To: ALL ISUZU DISTRIBUTORS AND SERVICE DEALERS
Subject: UPDATED FUEL SUPPLY AND RETURN LINE BANJO BOLT FOR ALL 4JJ1 ENGINES

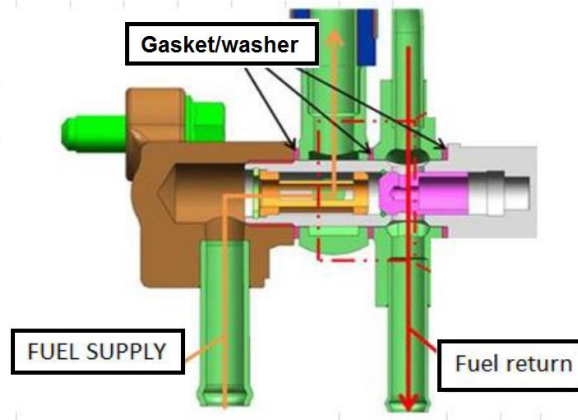
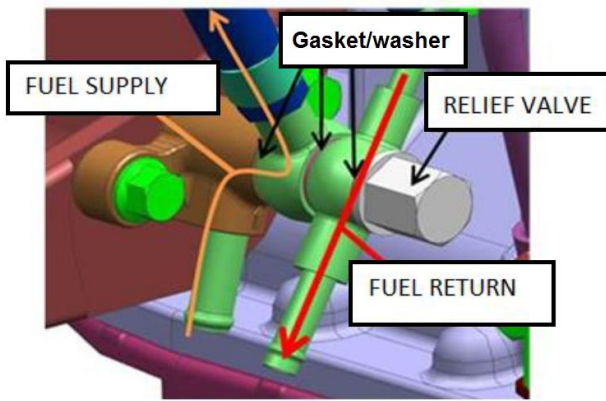
Isuzu Motors America, LLC strives to keep information up to date for our network. There has been a recent update regarding the fuel supply and return line banjo bolt for all 4JJ1 engines. Please see pictures below.

The new Banjo Bolt features a Boss in between the supply and return lines, which will require copper washers/gaskets to be installed on both sides of each fuel line. (Please note for purchasing and stocking, copper washers/gaskets needed).
